PRELIMINARY PLAT MAP
OF
NORMANDY HEIGHTS - PDR
PTN OF THE SE1/4, OF THE SE1/4 OF SEC. 35, 20 N., RGE 4 E., W. M.
CITY OF PUYALLUP, PIERCE COUNTY, WASHINGTON STATE

PRELIMINARY CIVIL PLANS
NORMANDY HEIGHTS - PDR

Job Number
12663

Job Number
12663
Sheet
8 of 12

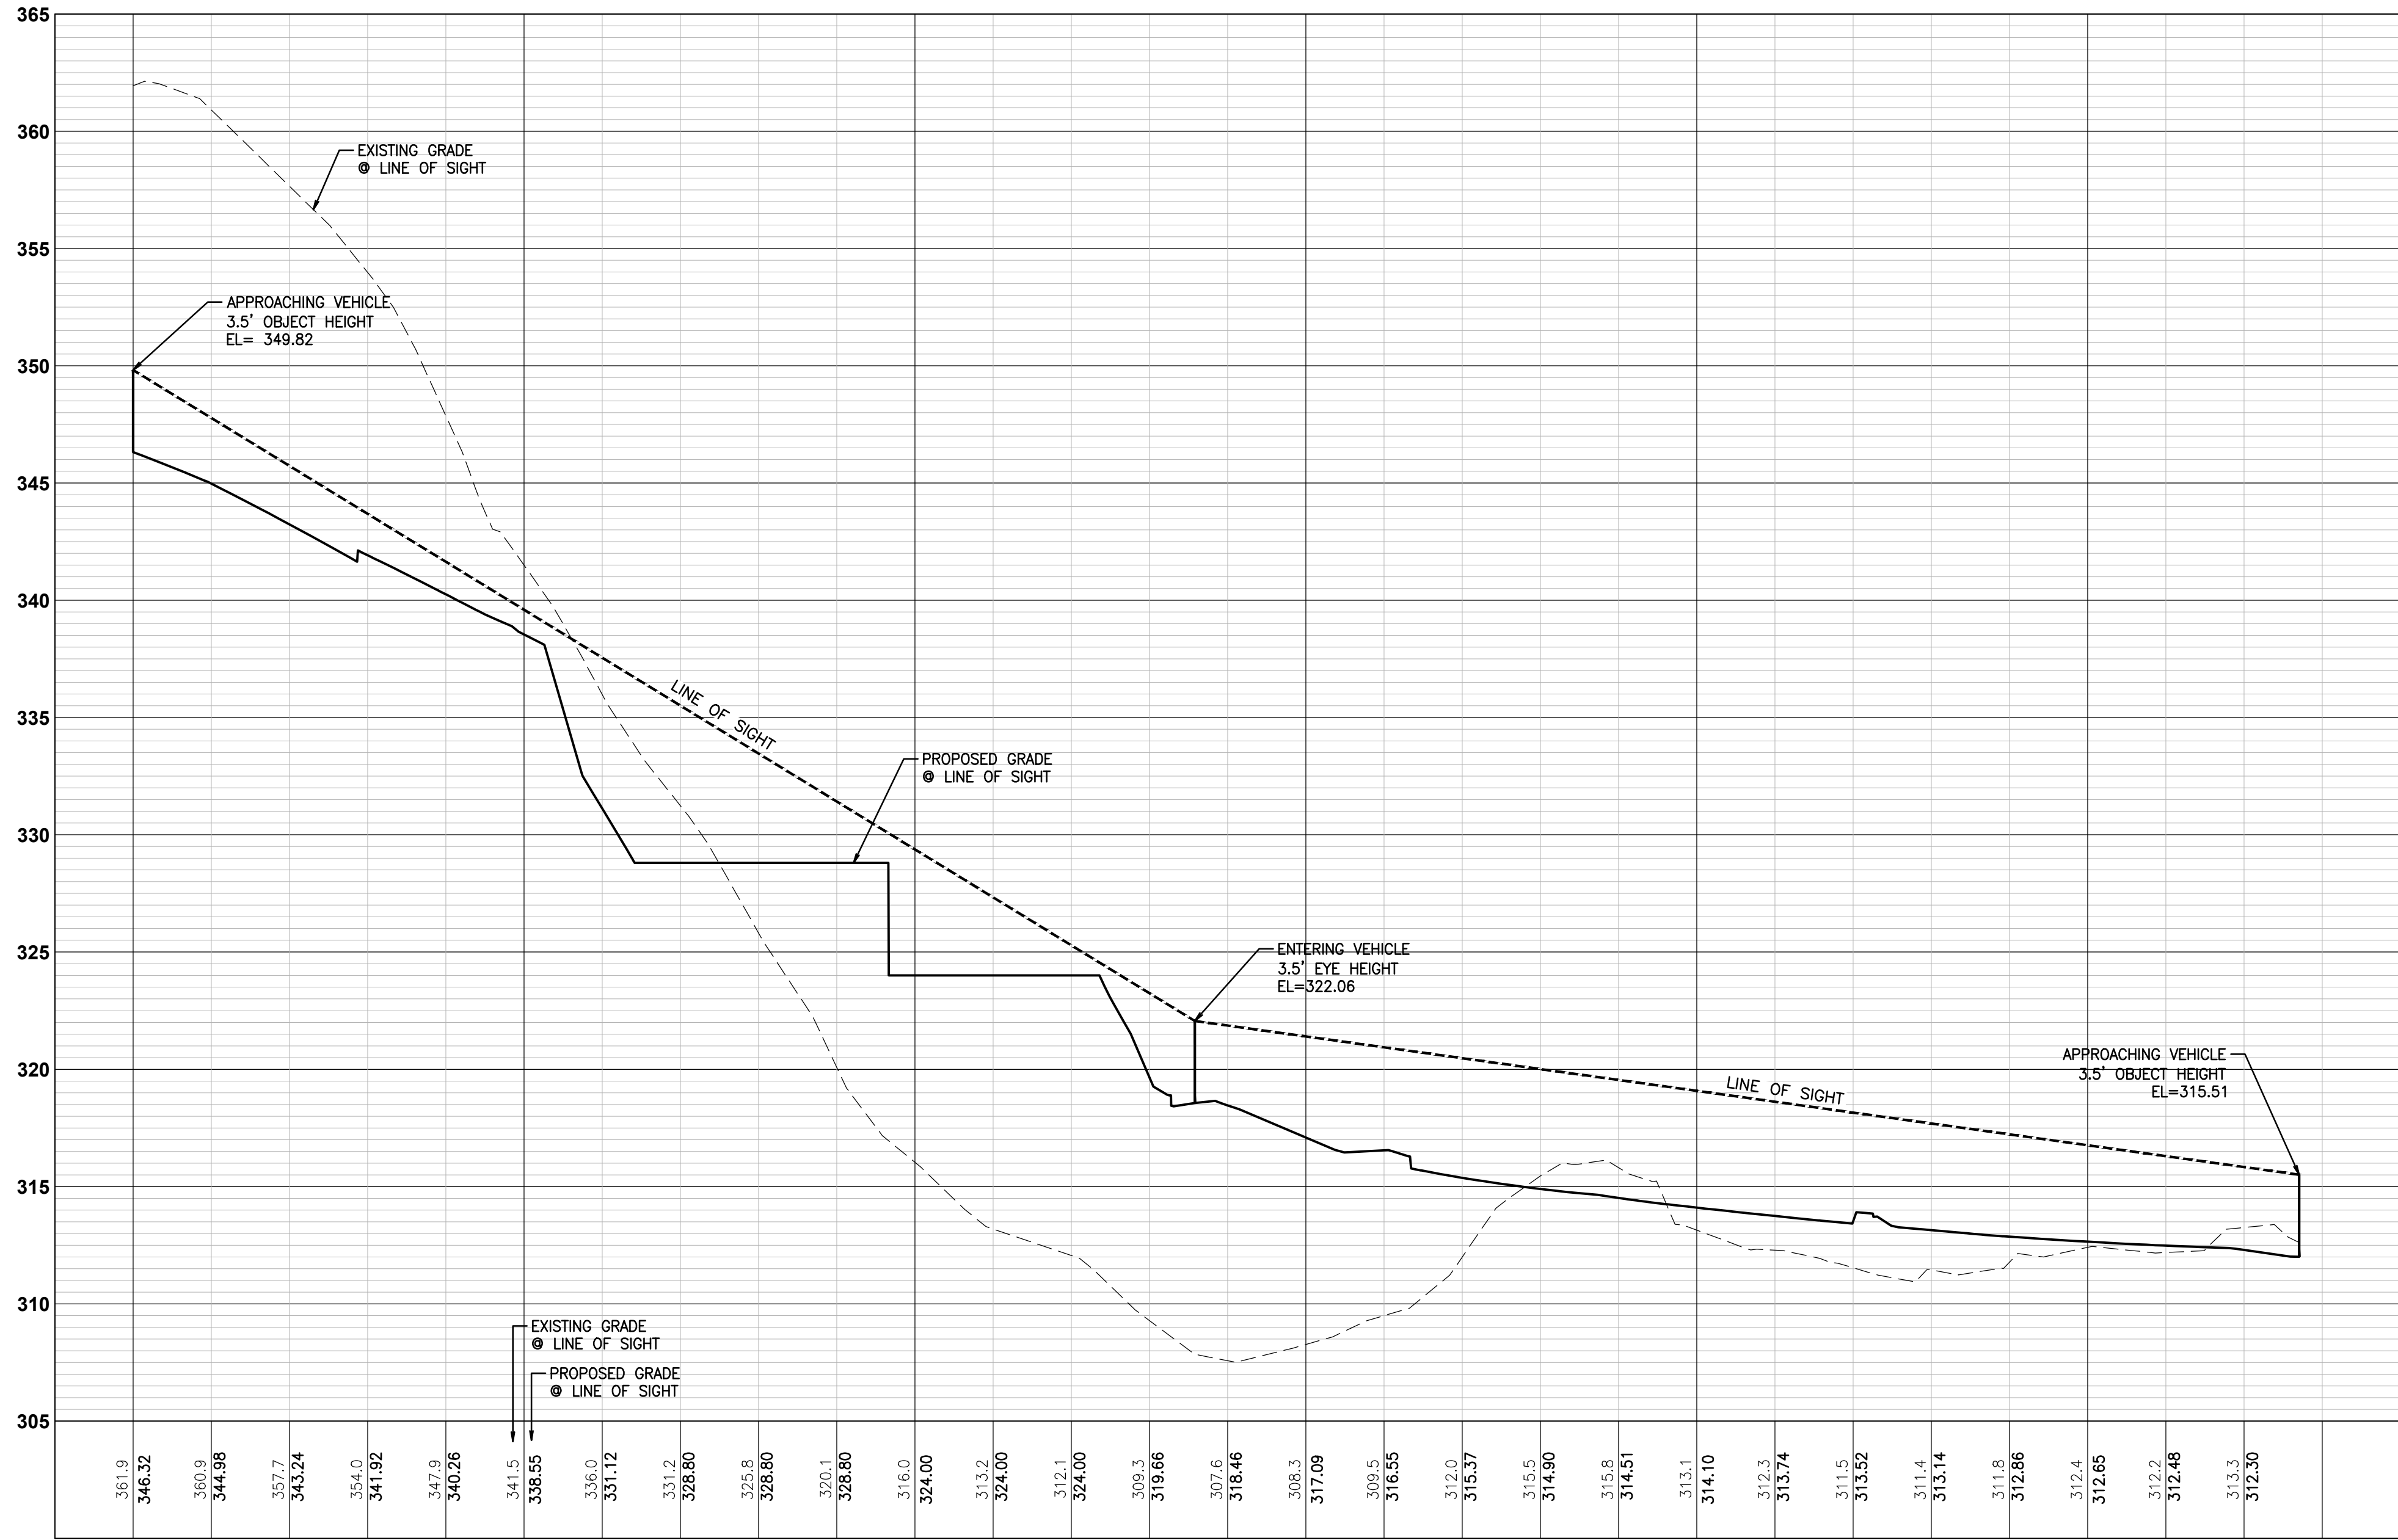
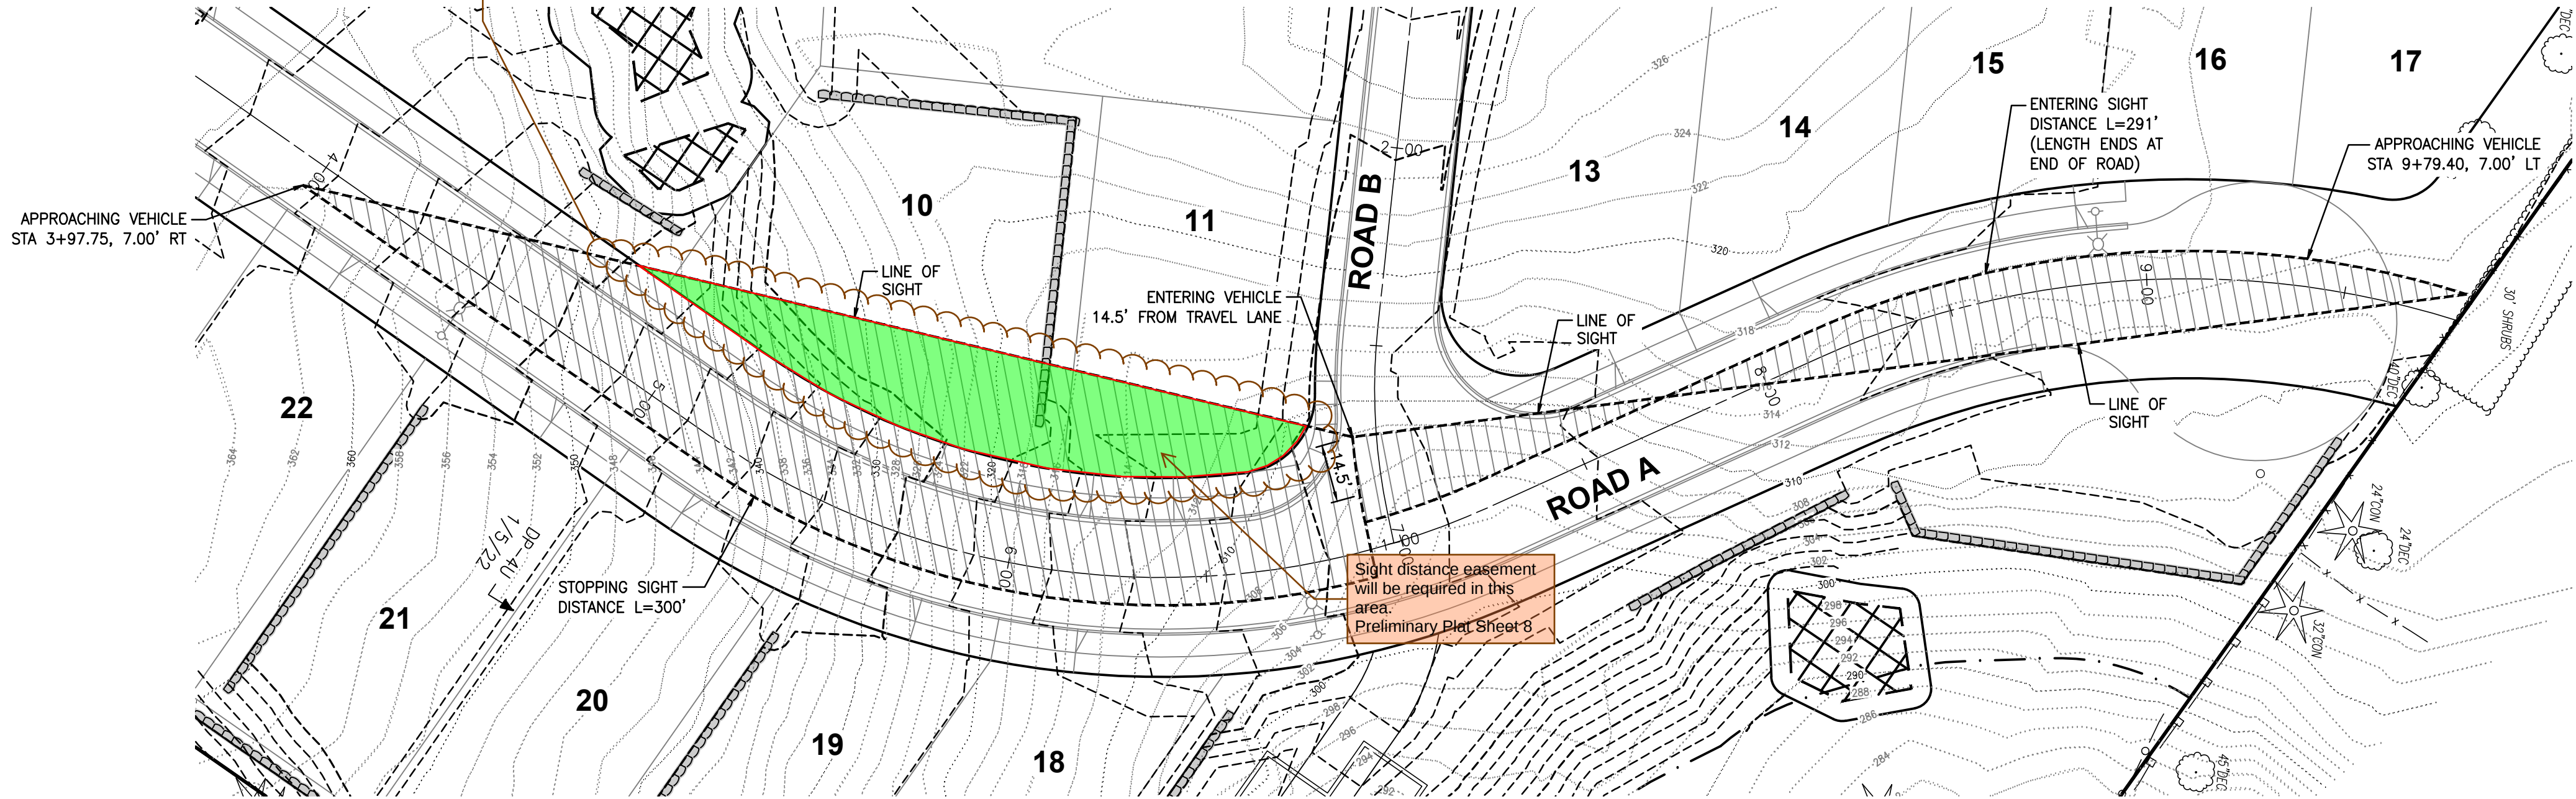
There will be no driveways, parking, trees, fences, landscaping, etc. along lot 10 & 11 "Road A" frontage due to sight distance conflicts. Adjust site plan accordingly. Sight distance easement will be required in this area. Preliminary Plat Sheet 8
